## Product Change Notice (PCN)

PCN Number: **PCN-0450984R-01**

Product(s) Affected: SJ1-3533N, SJ1-3534N, SJ1-3535N

<p>PCB LAYOUT TOP VIEW</p>	 <p>Recommended PCB Layout Top View</p>

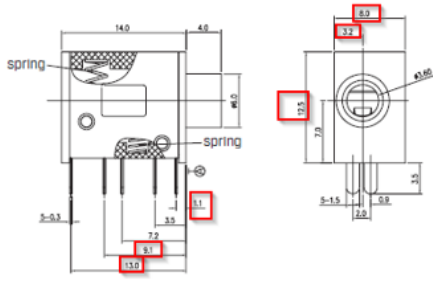
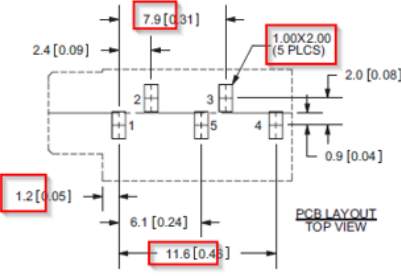
Description of Change: mechanical and material differences as shown below:

MATERIAL	PLATING
terminal 1	brass	tin
terminal 2	brass	tin
terminal 3	brass	tin
terminal 4	brass	tin
terminal 5	brass	tin
bushing	brass	nickel
spring	stainless steel	
plastic	PBT

DESCRIPTION	MATERIAL	PLATING/COLOR
terminal 1	brass t=0.30	silver
terminal 2	brass t=0.30	silver
terminal 3	brass t=0.30	silver
terminal 4	brass t=0.30	silver
terminal 5	brass t=0.30	silver
springs	stainless steel	
bushing	copper alloy (H59)	nickel
housing	PBT (UL94V-0)	black
cover	PBT (UL94V-0)	black
